Note to P802.3bn Editors/Task Force: the RxMER value to be stored per subcarrier needs to be an 8 bit unsigned integer with a value of 0 to 255. This value represents increments of 0.25 dB steps from 0 db (value 0x00) to 63.50 dB (value 0xFE). The value 0xFF is defined to mean that the RxMER cannot be measured for that subcarrier as explained in the text below. If this draft text is approved, this also includes the adding of an 8-bit RxMER value type or the modification of existing/anticipated RxMER value type per subcarrier).

Note to P802.3bn Editors: This is a new subsection to be placed under CL 100, CNU receiver functional requirements. Suggest adding as a new subsection: 100.2.11.3 (replacing anything else that was there).

101.2.11.3 Receive modulation error ratio requirements

Figure 100-X-1 - Computation of Received Modulation Error Ratio (RxMER) for a given subcarrier

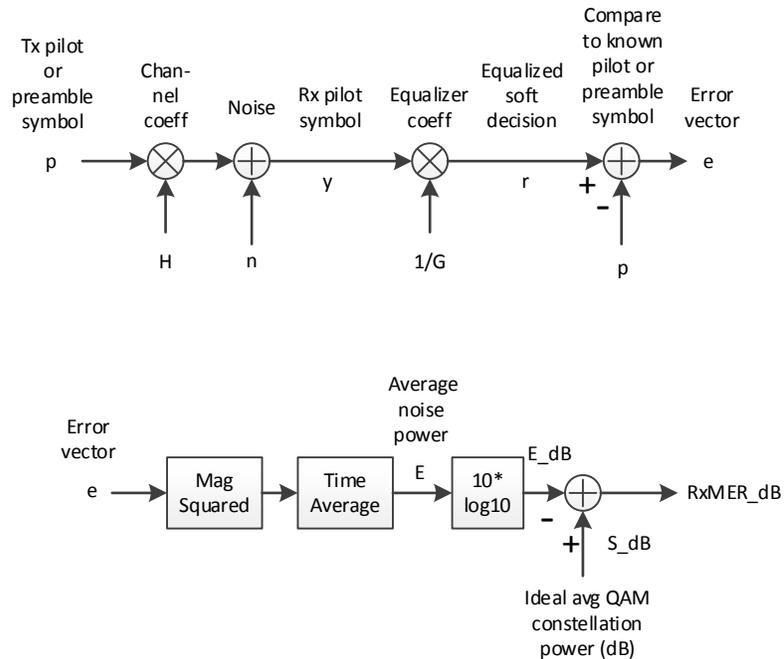
RxMER may be more clearly defined in mathematical notation in accordance with Figure 100-X-1, which shows an ideal transmit and receive model, with no intent to imply an implementation. Let p represent the pilot or PHY Link preamble symbol before transmit IDFT, H presents the channel coefficient for a given subcarrier frequency, n represents noise, $y = H * p + n$ is the unequalized received symbol after receive FFT. The receiver computes G as an estimate of H , and computes the equalized received symbol as $r = y / G$. Using the known modulation value of the pilot or preamble symbol p , the receiver computes the equalized error vector as $e = r - p$. All the above quantities are complex scalars for a given subcarrier. To compute RxMER, the receiver computes E as the time average of $|e|^2$ (squared absolute value) over many visits of the pilot to the given subcarrier (or PHY Link preamble symbol as applicable), and $E_{dB} = 10 * \log_{10}(E)$. Let S_{dB} be the average power of the ideal QAM data subcarrier constellation (not including pilots) expressed in dB. The CNU reports $RxMER_{dB} = S_{dB} - E_{dB}$. The CNU shall be capable of providing measurements of RxMER for all active subcarrier locations for each OFDM downstream channel, using pilots and PHY Link preamble symbols.
